# Comment Letter A

Re: **Almaden Office Project, File No. SP20-005**  
State Clearinghouse # 2019050020 (Almaden Office Project NOP)  
State Clearinghouse # 2003042127 (Almaden Office Project SEIR, Downtown Strategy)

The California Native Plant Society, Santa Clara Valley Chapter (CNPS SCV) appreciates the opportunity to provide input on the Supplemental Environmental Impact Report (SEIR) for the Almaden Office Project. CNPS is a non-profit environmental organization, established in 1965, whose mission is to protect California's native plant heritage and preserve it for future generations through the application of science, research, education, and conservation. The CNPS Santa Clara Valley Chapter has over 1,000 members distributed throughout our chapter area, which encompasses all of Santa Clara County and southern San Mateo County.

Figure 1. Site Map

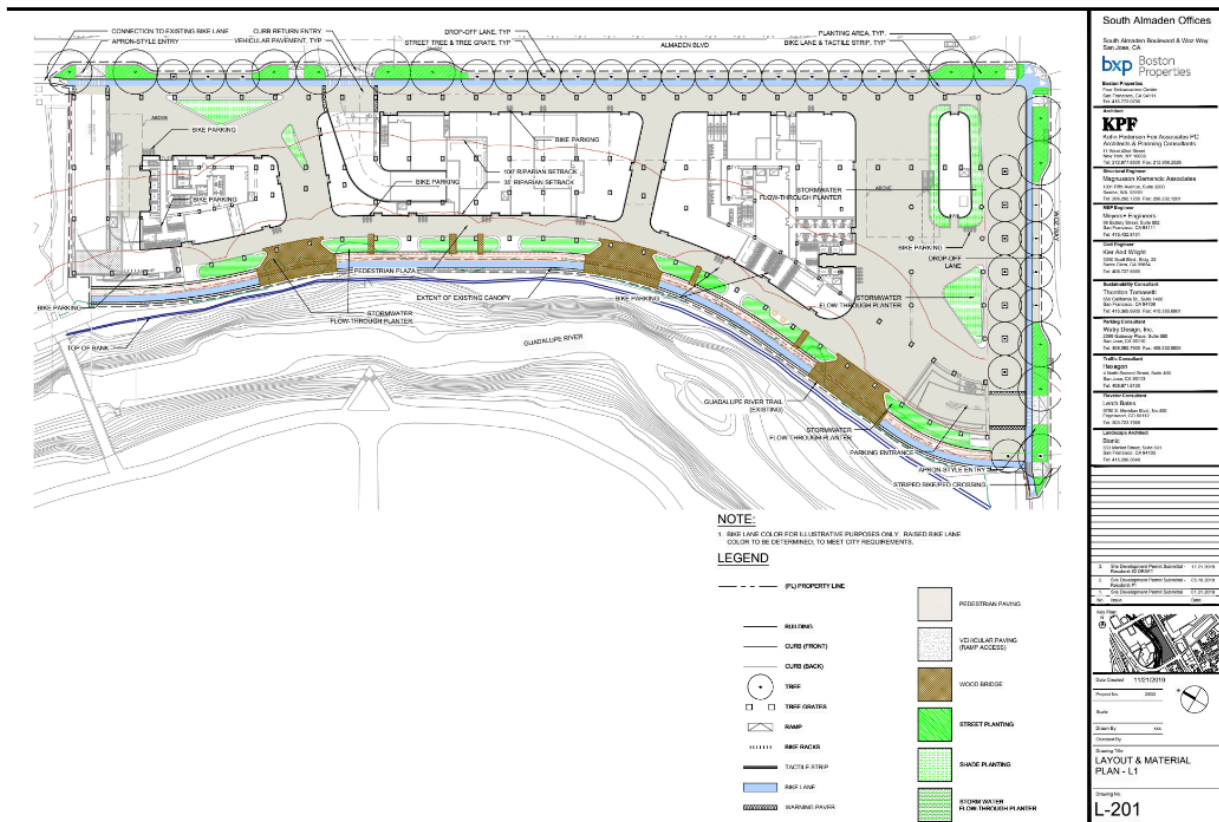
As proposed, the Project **does not** achieve the biological goals and objectives of the Habitat Plan and conflicts with the Habitat Plan stream setback requirements for development adjacent to a Category 1 stream.

The Habitat Agency recommends the applicant redesign the project to minimize to the maximum extent possible any encroachment into the required Category 1 stream 100-foot stream setback. The Habitat Agency agrees with all mitigation measures included in the Project Biological Resources Report (HTH #4230-01) and supports the inclusion of those mitigation measures in any Project approval contemplated by the City.
